The Great Grid Upgrade

Norwich to Tilbury

2023 Non-Statutory Consultation Feedback Report

AENC-NG-CNS-REP-0007

Figure 4.11 - South Norfolk section map

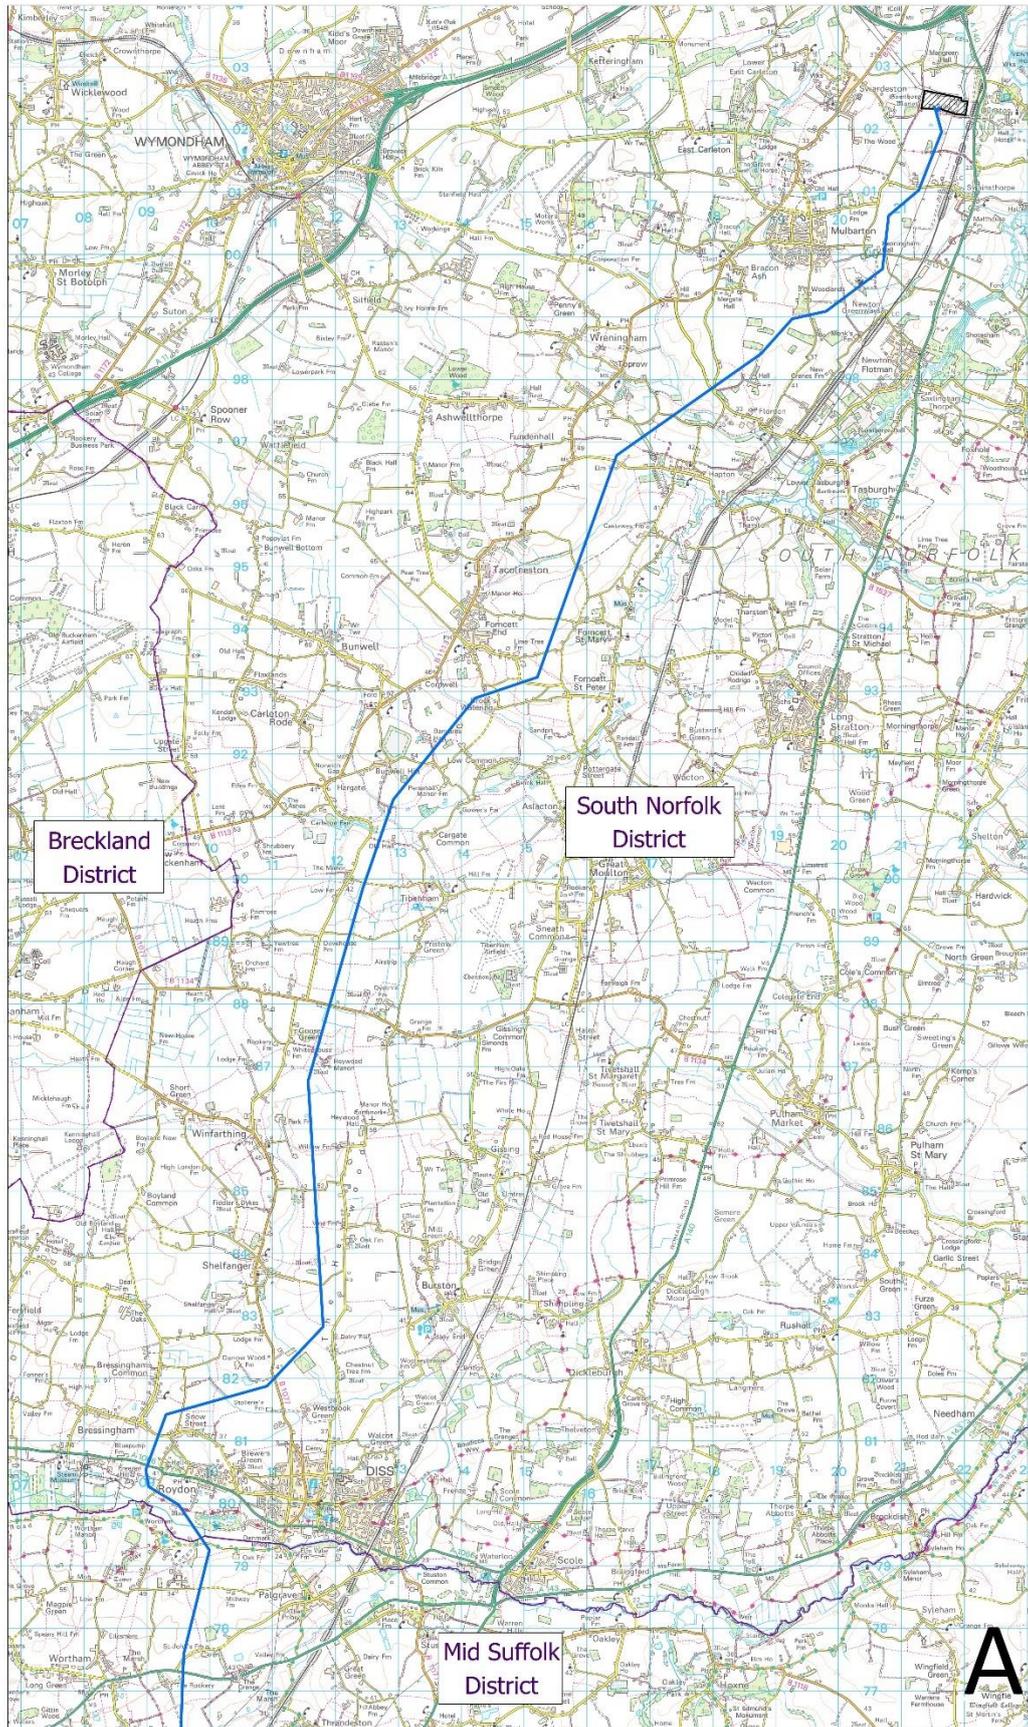
Ref no.	Summary of matters raised	National Grid's response
Agricultural Land		
4.3.1	Concern that the Project will take away valuable agricultural land / disrupt farming operations.	National Grid is and will continue to work with all landowners including farmers who may be affected by the proposals to understand the impacts on their operations and to work with them as the Project is developed. We will seek to work with the farming community to limit disruption where practicable. This includes providing prior warning of works which may result in the need to move livestock. Compensation claims for disturbance are considered on a case-by-case basis, if negative impact on farming operations can be proven. Particular agricultural matters can also be addressed through voluntary land agreements.
Airfields

Figure 4.12- Mid Suffolk section map

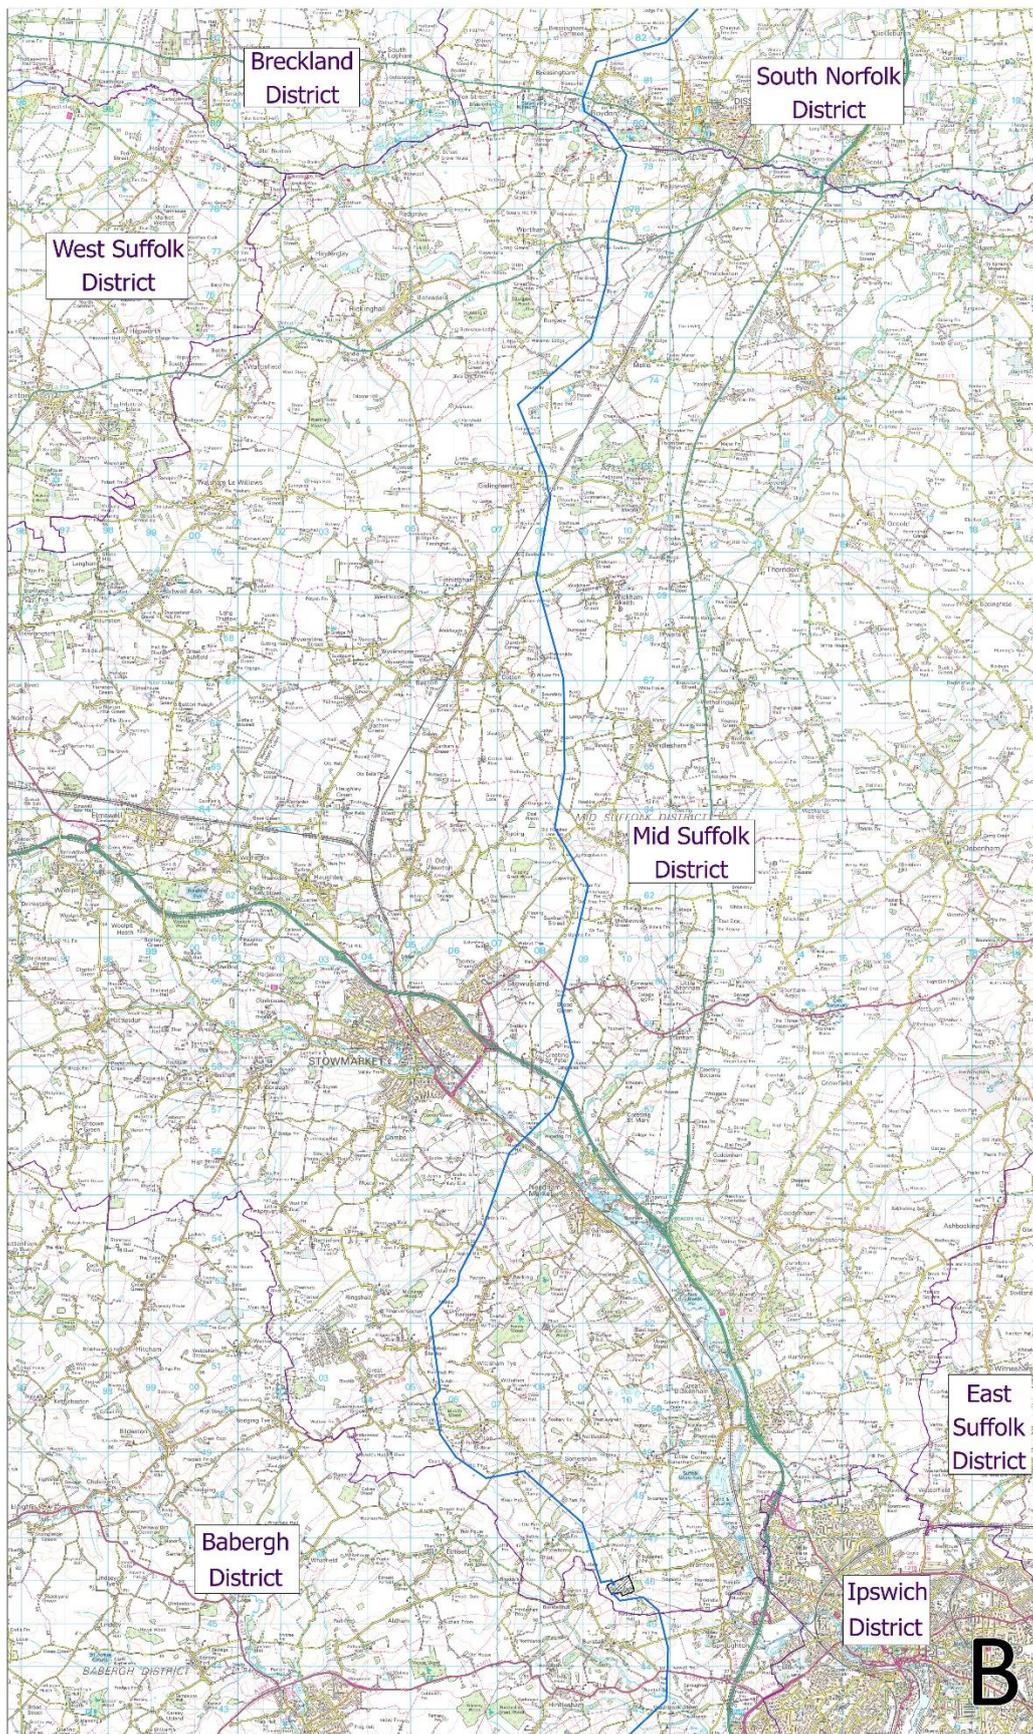
Ref no.	Summary of matters raised	National Grid's response
Agricultural Land		
4.4.1	Concern about the impact of the Project on drainage (for agricultural land).	Drainage surveys will be carried out in advance of construction works and will include on-site assessments and engagement with affected landowners. Existing drainage will be avoided where reasonably practicable. Where it cannot be avoided, it will be rerouted or temporary drainage will be installed for the construction period.

Figure 4.13- Babergh, Tendring and Colchester section map

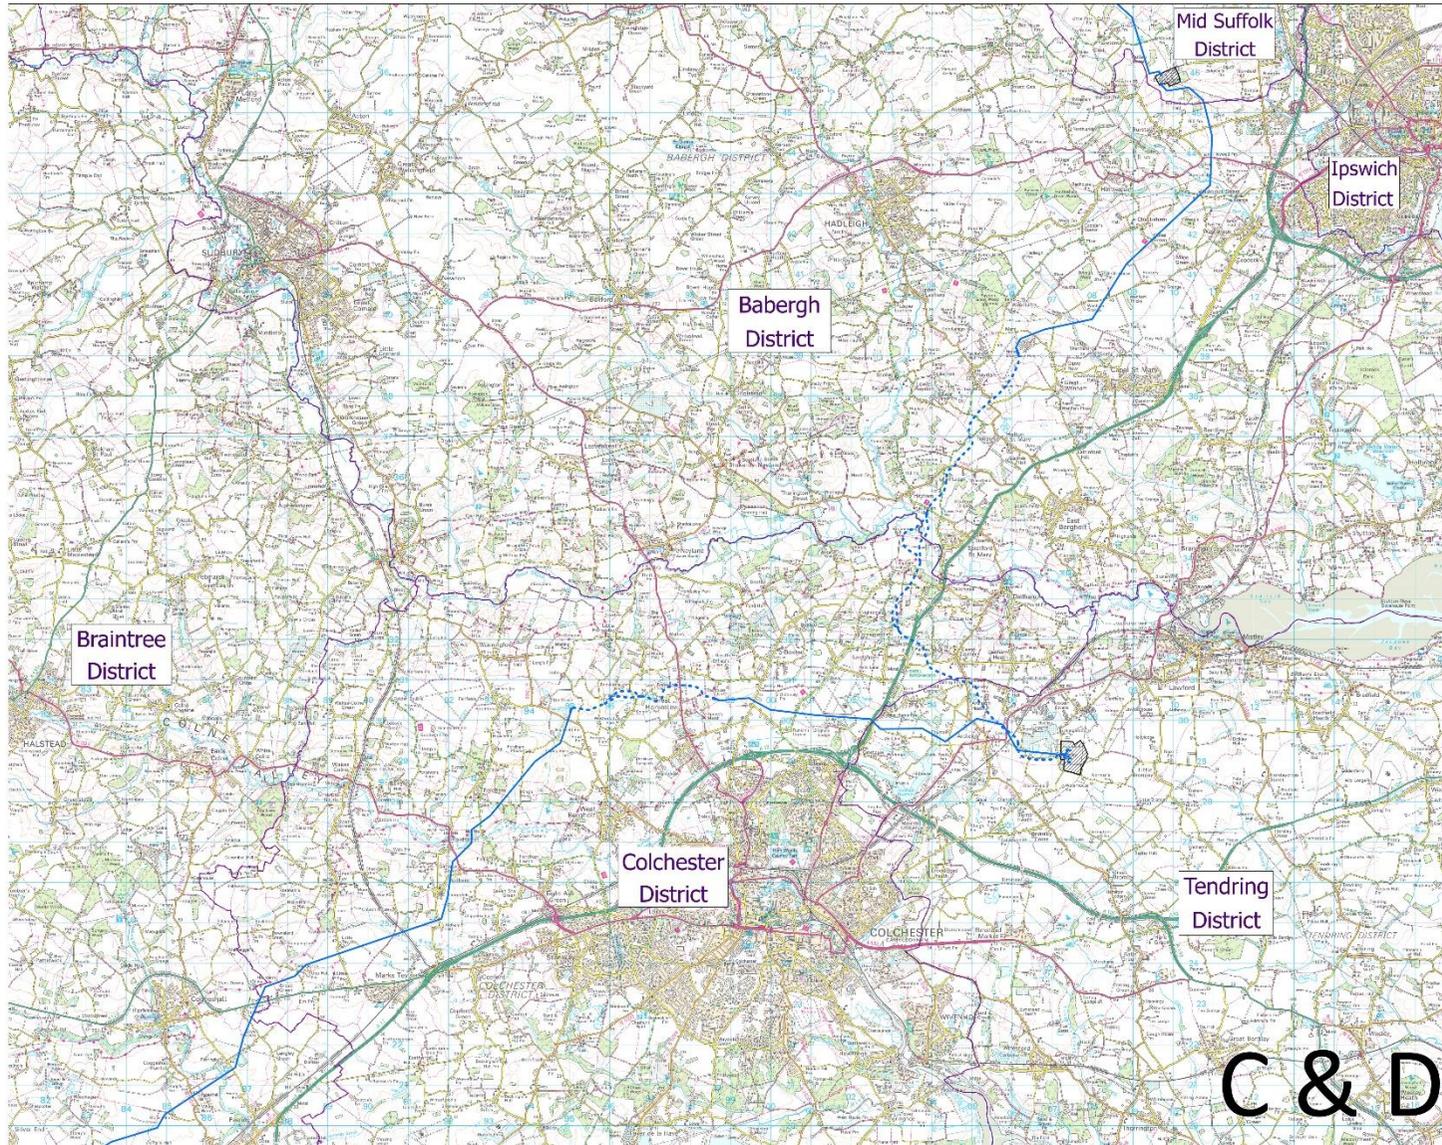
Ref no.	Summary of matters raised	National Grid's response
Agricultural Land		
4.5.1	Concern that the Project will take away valuable agricultural land / disrupt farming operations.	National Grid is and will continue to work with all landowners including farmers who may be affected by the proposals to understand the impacts on their operations and to work with them as the Project is developed. We will seek to work with the farming community to limit disruption where practicable. This includes providing prior warning of works which may result in the need to move livestock. Compensation claims for disturbance are considered on a case-by-case basis, if negative impact on farming operations can be proven. Particular agricultural matters can also be addressed through voluntary land agreements.

Figure 4.15 Chelmsford section map

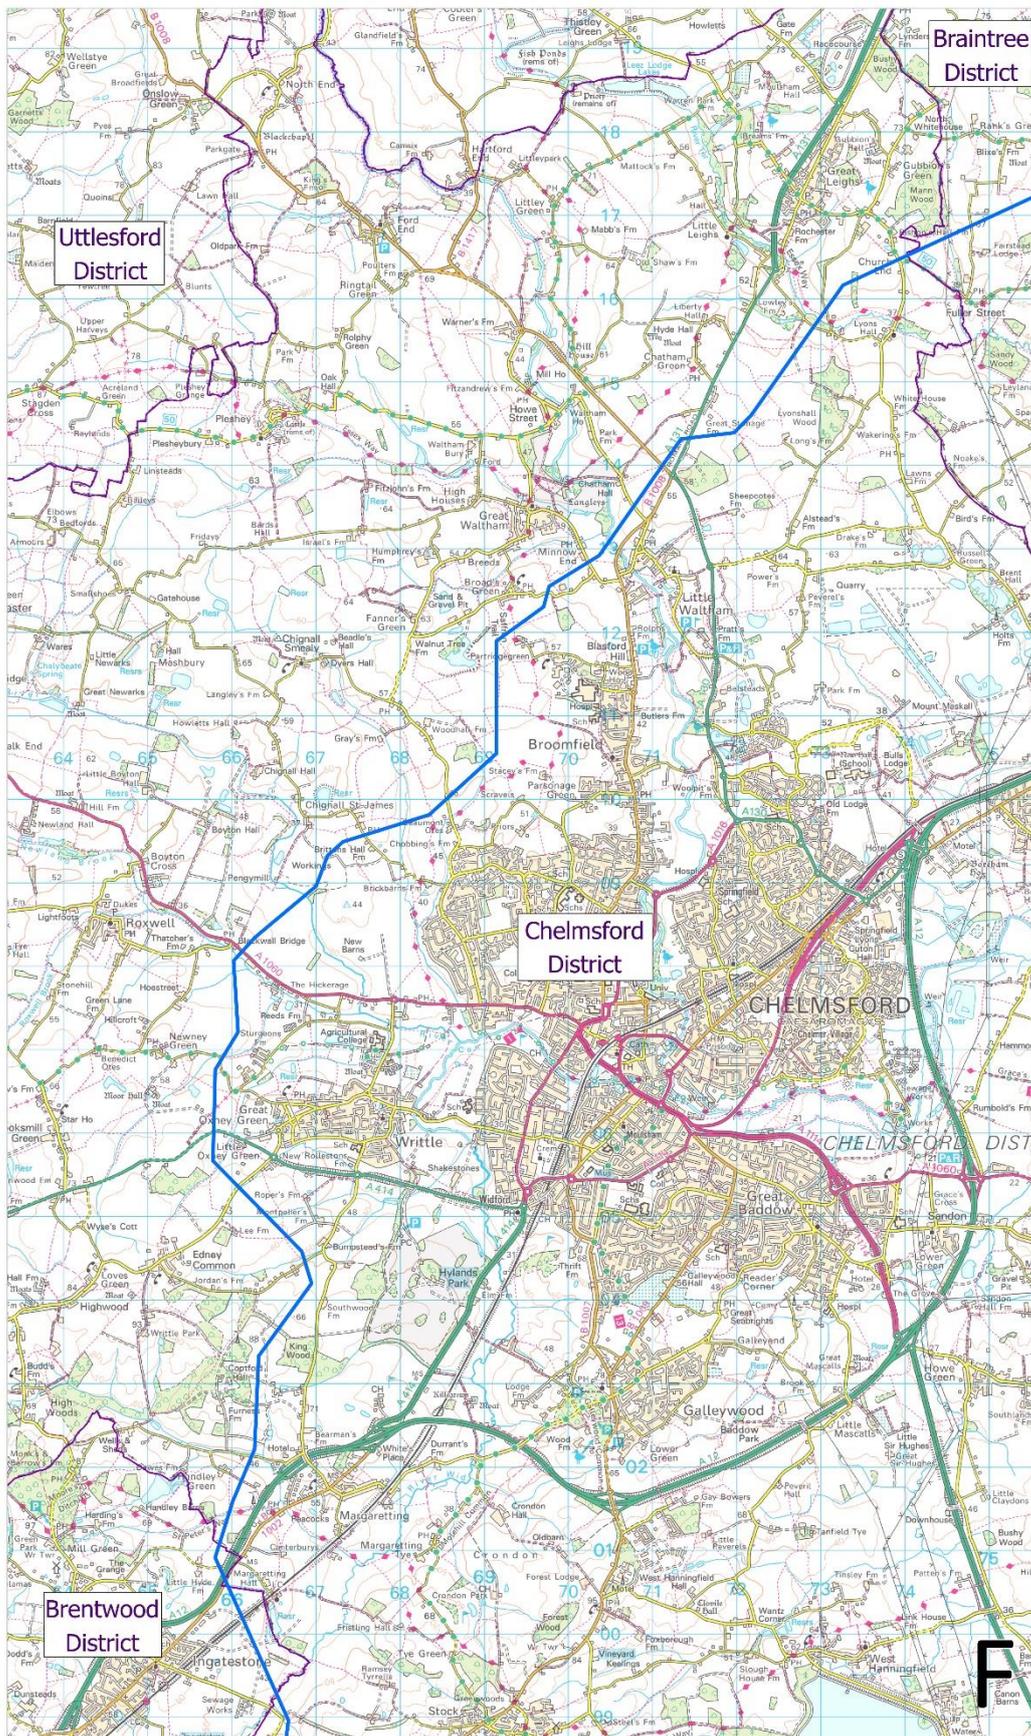
Ref no.	Summary of matters raised	National Grid's response
Agricultural Land		
4.7.1	Concern that the Project will take away valuable agricultural land / disrupt farming operations.	National Grid is and will continue to work with all landowners including farmers who may be affected by the proposals to understand the impacts on their operations and to work with them as the Project is developed. We will seek to work with the farming community to limit disruption where practicable. This includes providing prior warning of works which may result in the need to move livestock. Compensation claims for disturbance are considered on a case-by-case basis, if negative impact on farming operations can be proven. Particular agricultural matters can also be addressed through voluntary land agreements.
Airfields

Figure 4.16- Basildon and Brentwood (and Chelmsford east of Ingatestone) section map

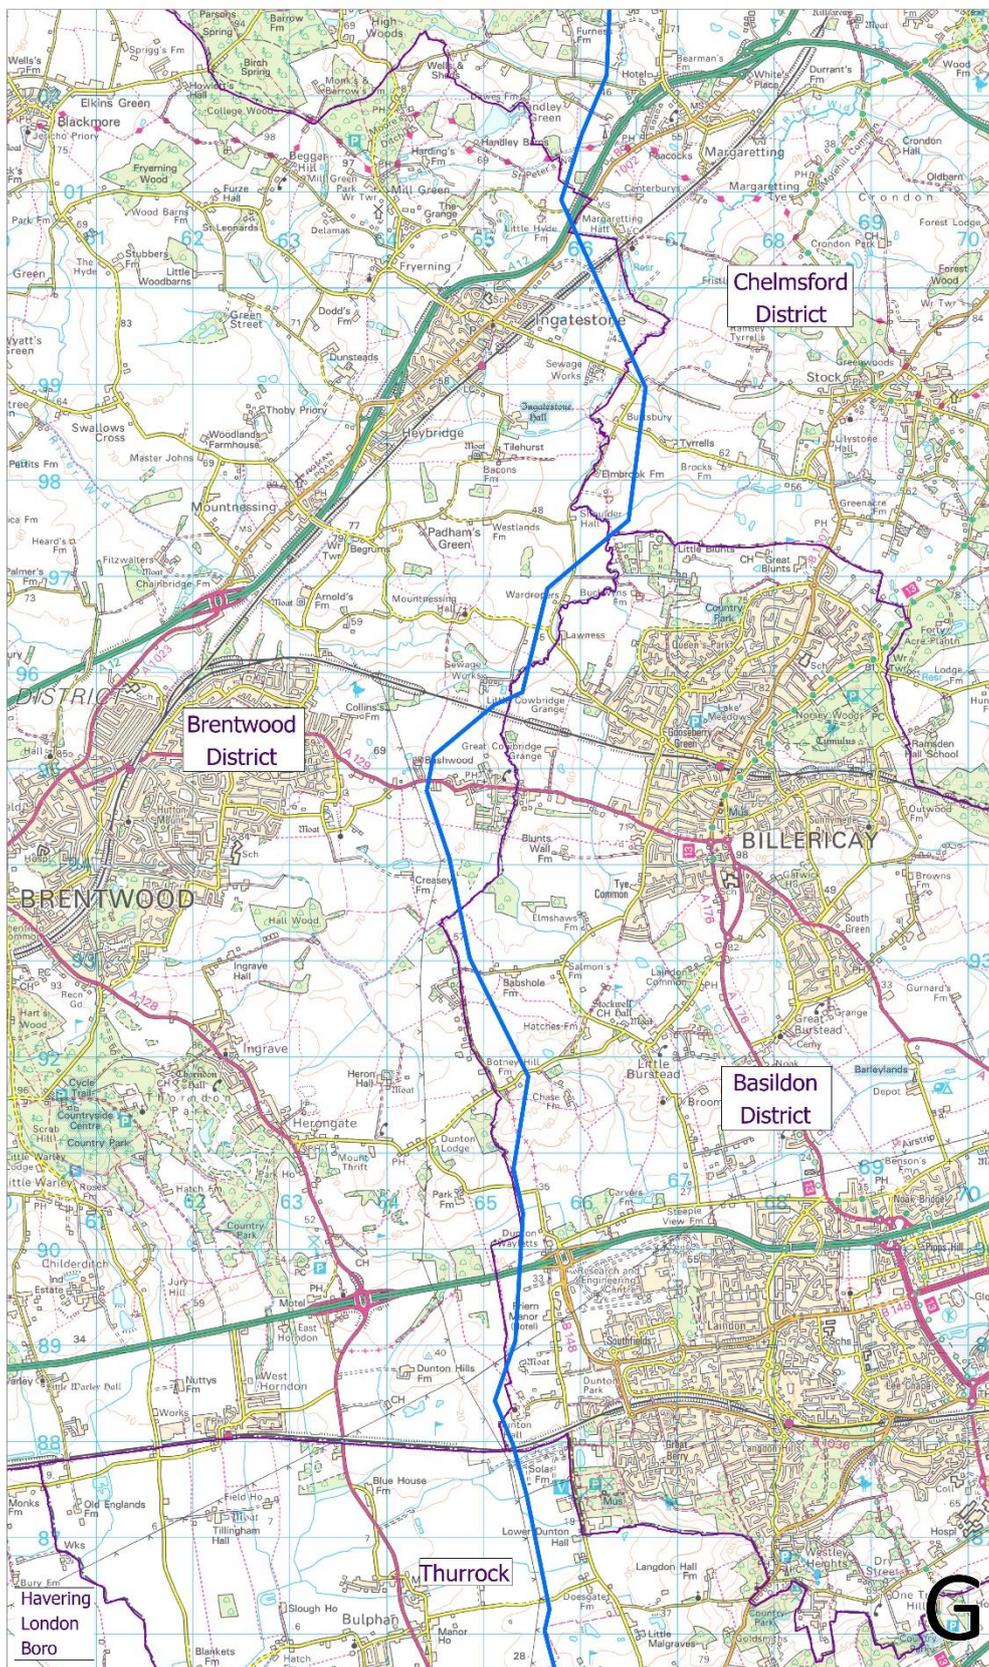
Ref no.	Summary of matters raised	National Grid's response
Agricultural Land		
4.8.1	Concern that the Project will take away valuable agricultural land / disrupt farming operations.	National Grid is and will continue to work with all landowners including farmers who may be affected by the proposals to understand the impacts on their operations and to work with them as the Project is developed. We will seek to work with the farming community to limit disruption where practicable. This includes providing prior warning of works which may result in the need to move livestock. Compensation claims for disturbance are considered on a case-by-case basis, if negative impact on farming operations can be proven. Particular agricultural matters can also be addressed through voluntary land agreements.
Airfields
